DESIGN SPECIFICATION

ACCESSIBILITY

Penrith City Council C/- Justin Long Design

1158-1160 Castlereagh Road, Castlereagh

Figure 2.1.1 –proposed floor plan

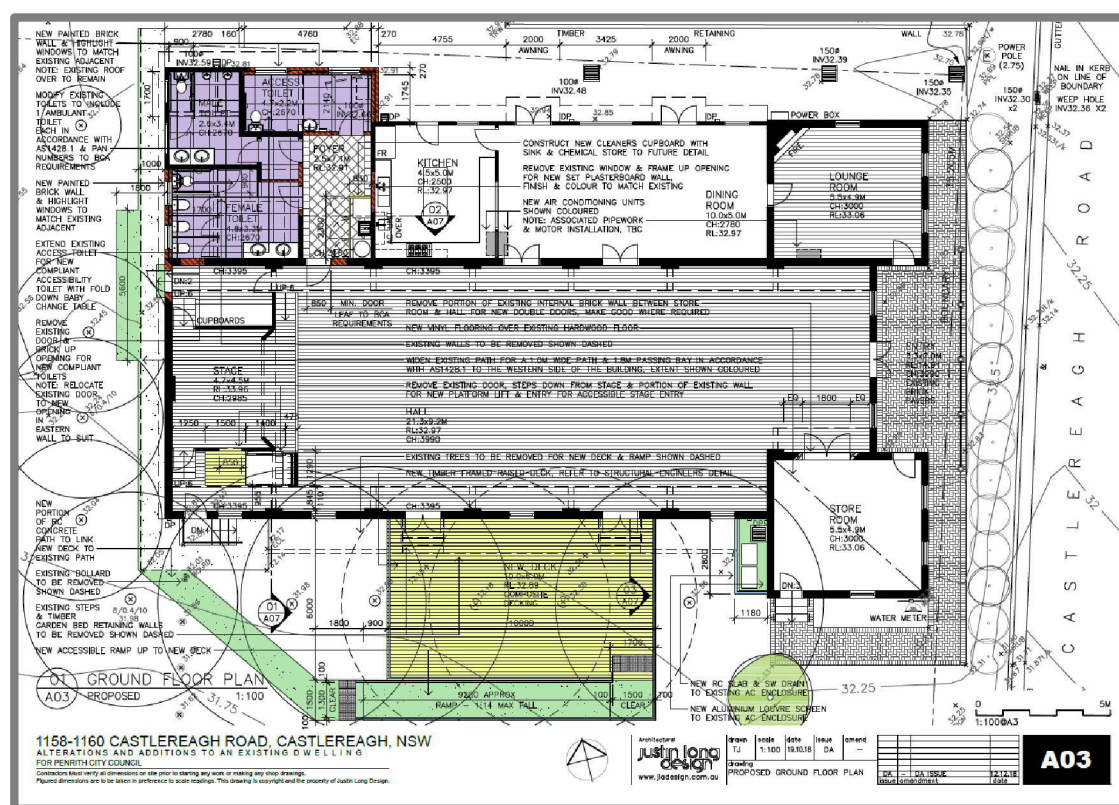
- (a) The retained double door leafs opening from the building opening from the hall out onto the new deck do not appear to have an individual door leaf not less than 850-mm (clear opening) in each doorway opening
- (b) The proposed ramp shall have a length longer than 9-metres without an intermediate landing
- (c) The balustrade to perimeter of the new deck and the ramp need be designed and constructed to AS 1428.1-2009, as includes the provision of kerb rails

- (a) The tactiles depicted at the top of the ramp, appear to be more than 300-mm from the top of the rap (where it meets the landing)

AS 1428.1-2009 compliant access for people with a disability is to be provided to and within all parts.

- (a) An unobstructed opening width to all new doorways, of not less than 850-mm
- (b) Floor surfaces, including changes in level, must be AS 1428.1-2009 compliant in terms of being non-slip;

AS/NZS 1428.4.1 compliant tactile ground surface indicators are to be provided to the top and bottom of the new ramp.
